Environmental Assessment for the Proposed Renewal of Source Material License SUB–526 Metropolis Works Uranium Conversion Facility (Massac County, Illinois)

Honeywell International, Inc. Docket No. 040-03392

October 2019

U.S. Nuclear Regulatory Commission Washington, D.C. 20555-0001

Figure 2-1 Facility Site Features at the MTW Site (Honeywell 2018a)

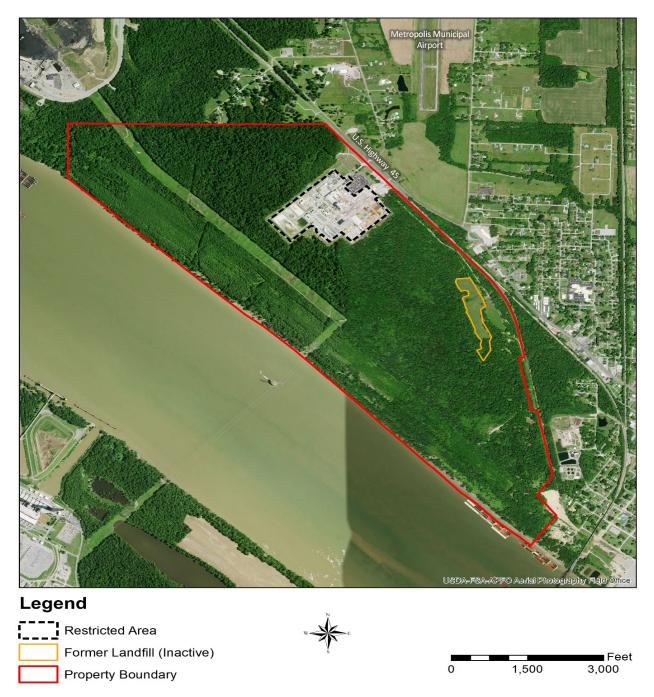
One commenter noted that EA Section 2.1, "General Site Location," incorrectly refers to Figure 1-2 to illustrate the restricted area. The commenter indicated that this is most likely a transcription error and the reference should be changed to Figure 2-1.

Response: The NRC agrees with the comment. In response to this comment, the NRC revised the first paragraph of Section 2.1 to refer to Figure 2-1 instead of Figure 1-2.

Figure 2-5 Offsite Environmental Monitoring Sampling Locations for Surface Water, Sediment, Soil, and Vegetation (Source: ENERCON 2017)

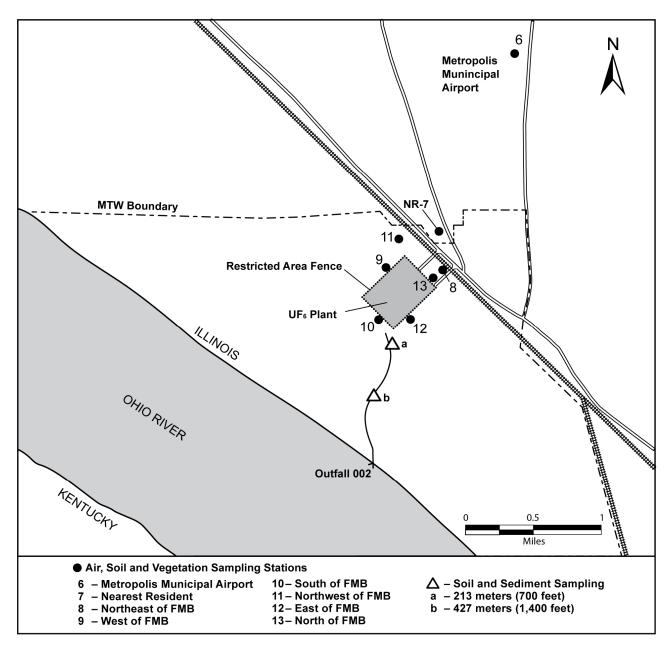
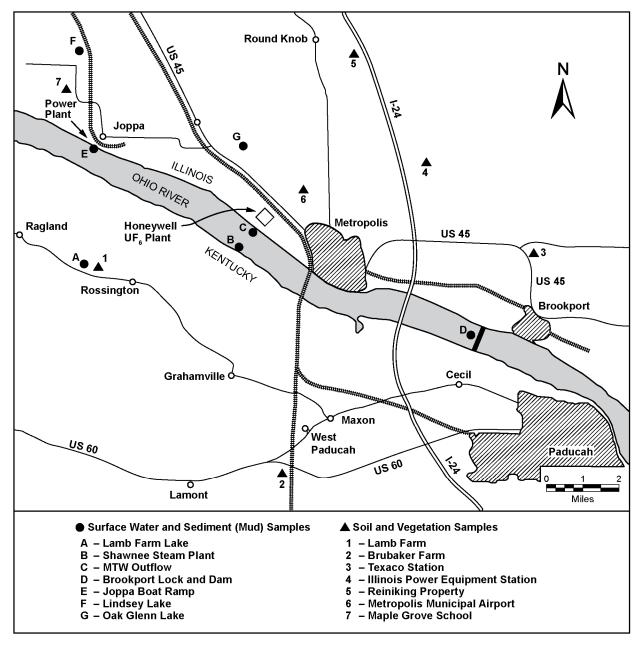
A commenter noted that EA Figure 2-5, "Environmental Monitoring Sampling Locations for Surface Water, Sediment, Soil, and Vegetation," does not display all of the sample locations listed in Table 2-7, 'Sediment Monitoring Annual Averages.' The commenter noted specifically the sample locations for the effluent channel and the sampling points labelled as North of FMB, West of FMB, South of FMB, Northwest of FMB, East of FMB, North of FMB, and Nearest Resident are missing from Figure 2-5. The commenter also noted inconsistencies in the labeling of locations in Figure 2-5 and Table 2-6, "Surface Water Monitoring Annual Averages."

Response: Figure 2-5 shows offsite sampling locations while EA Figure 2-4, "Environmental Air, Soil, and Vegetation Sampling Locations," focuses on sampling locations on the MTW site. In response to this comment, the NRC revised Figure 2-4 and Figure 2-5 to show the location of all sampling locations shown in the tables and to ensure consistency in labeling.

Figure 2-6 Location of Groundwater Monitoring Wells Associated with the Sanitary Well and Calcium Fluoride Ponds Monitoring Programs (Source: ENERCON 2017)

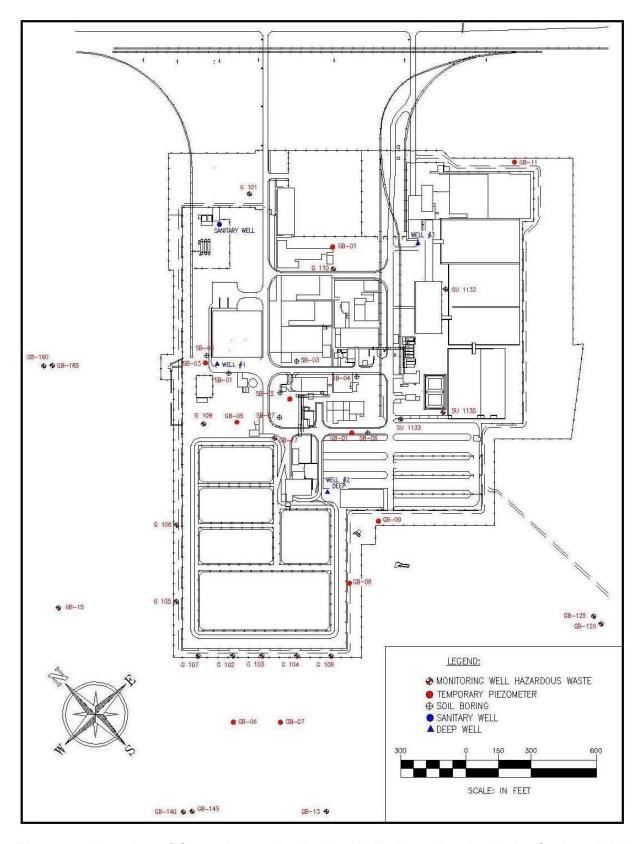
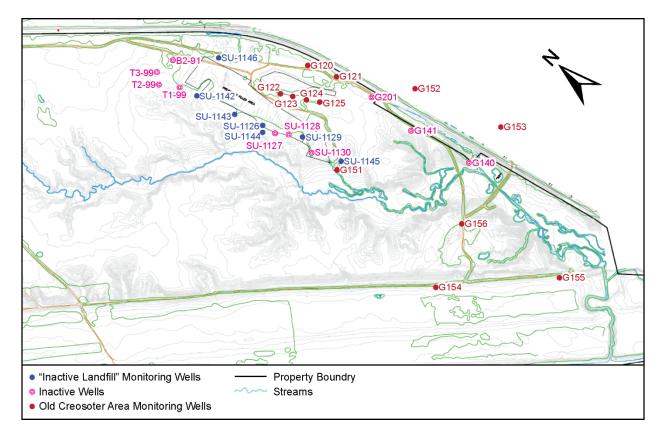
A commenter stated that text in the first paragraph after the bullet points in the Groundwater Monitoring section within EA Section 2.3.9.2 refers to EA Figure 2-6, "Location of Groundwater Monitoring Wells Associated with the Calcium Fluoride Ponds," for the locations of the groundwater wells for the sanitary well and process well monitoring, the calcium fluoride pond monitoring program, and inactive landfill area monitoring program. However, the commenter noted that Figure 2-6 does not show the wells for the landfill monitoring program. In addition, the commenter noted that the figure does not show monitoring well locations for the Old Creosoter Area monitoring program.

Response: In response to this comment, the NRC staff revised the EA to illustrate the location of groundwater monitoring wells in two figures that cover all known active monitor wells at the facility: an updated Figure 2-6 and a new Figure 2-7. Figure 2-6 shows groundwater monitoring wells across the western half of the facility, including the Restricted Area and wells downgradient. Figure 2-7 shows groundwater monitoring wells across the eastern half of the facility, including the Inactive Landfill and the Old Creosoter Area.

Figure 3-1 Environmental Land Use Control Boundary and Surface Water Features (Source: Honeywell 2018a, RAI Responses Figure 3.4-3)

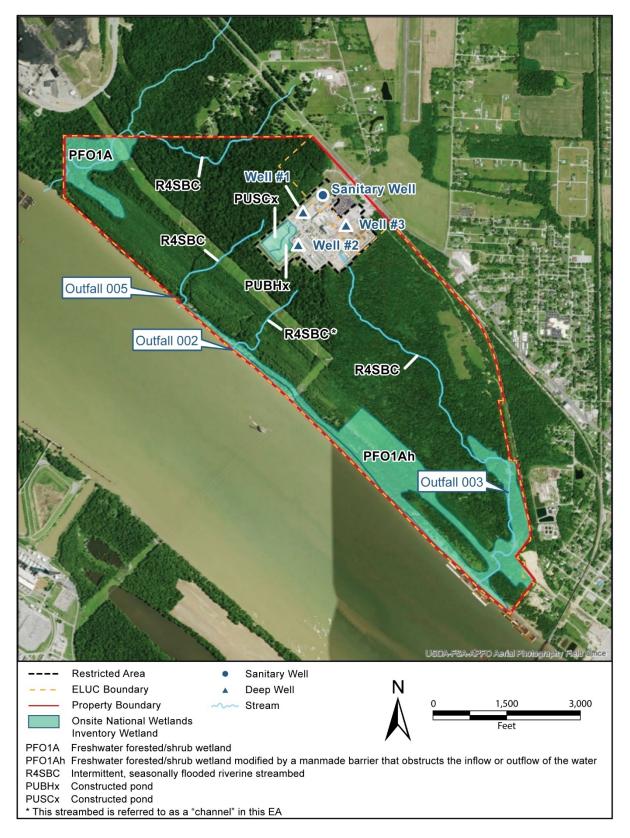
A commenter stated that EA Figure 3-4, "Surface Water Features," includes undefined labels for what apparently are wetlands and creeks. The commenter recommended defining these locations and identifying which creek discharges to NPDES Outfall 002, as mentioned in EA Section 3.4.1.1. In addition, the commenter recommended combining EA Figures 3-1 and 3-4 for clarity.

Response: The NRC staff agrees that the labels for wetland designations in Figure 3-4 of the draft EA should be defined. The wetlands are defined as follows (USFWS 2017):

In response to this comment, the NRC staff combined Figures 3-1 and 3-4 of the draft EA to create a new Figure 3-1 for the final EA and added the above wetland descriptions to the key of the new figure.
